Proposal for improvement of ECE/TRANS/WP.29/GRE/2019/3 (draft new [07] series of amendments to UN Regulation No. 48 (Installation of lighting and light-signalling devices))

The text reproduced below was prepared by expert from Poland, on the basis of document ECE/TRANS/WP.29/GRE/2019/3, with the purpose to improve the proposed range for aiming/levelling to make it performance based and to guarantee minimum road illumination distance of 50m and the same maximum glare conditions for beyond 25m independently on mounting height of headlamp.

The above limits ~~and the initial aiming values~~ are summarized in the diagram below.

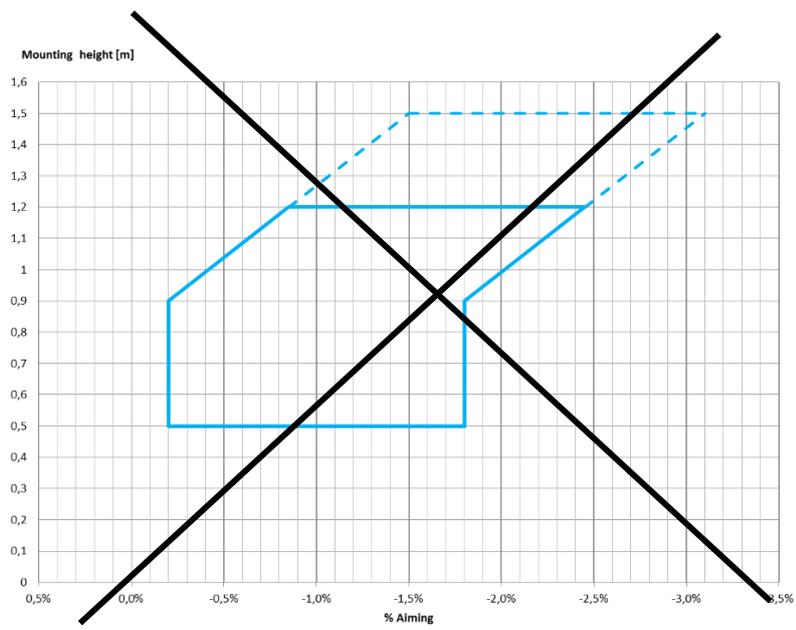
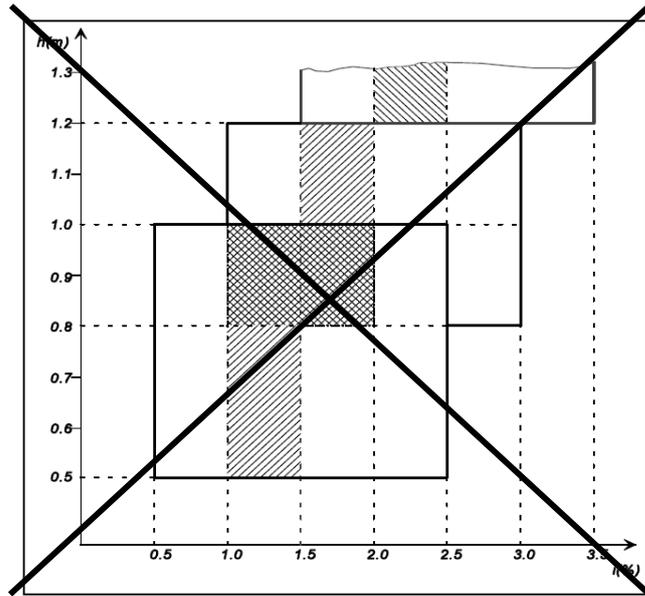
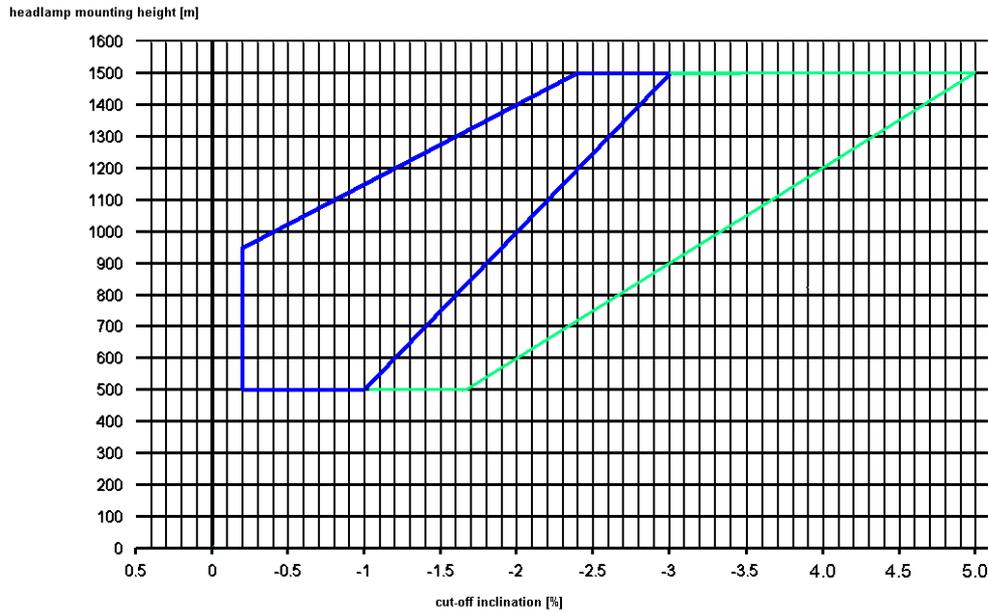
6.2.6.1.2. Depending on the mounting height in metres (h) of the lower edge of the apparent surface in the direction of the reference axis of the dipped-beam headlamp, measured on the unladen vehicles, the vertical inclination of the cut-off of the dipped beam, **starting from the initial inclination value set by the vehicle manufacturer as prescribed in paragraph 6.2.6.1.1. above**, shall ~~under all the static conditions of Annex 5,~~ remain between the following limits, **under all the stating loading conditions of Annex 5:**

for 0.5 m < h < 0.95 m, between:

the highest vertical inclination limit is -0.2 %

for 0.95 m < h < 1.2 m, between:

the ~~minimum~~ **highest** vertical inclination limit increasing linearly, in relation to the dipped-beam headlamp mounting height,

from - 0.2 % to ~~-2.4~~ **-0.8** %]

for 0.5 m < h < 1.5 m

the ~~maximum~~ **lowest** vertical inclination limit increasing linearly, in relation to the dipped-beam headlamp mounting height,

from - 1.08 % to ~~-2.4~~ **-3.0** %;

[In the case of vehicle which maximum speed is restricted by design to 50km/h

category N₂G (off road) vehicles: , where the headlamps exceed a height of 1,200 mm the limits for the vertical inclination of the cut off shall be between: 1.5 per cent and 3.5 per cent

for 0.5 ~~1.2~~ m < h < 1.5 m, between:

the ~~minimum~~ **lowest** vertical inclination limit increasing linearly, in relation to the dipped-beam headlamp mounting height,

from ~~-1.7~~ **-0.8** % to ~~-1.5~~ **-5.0** %]
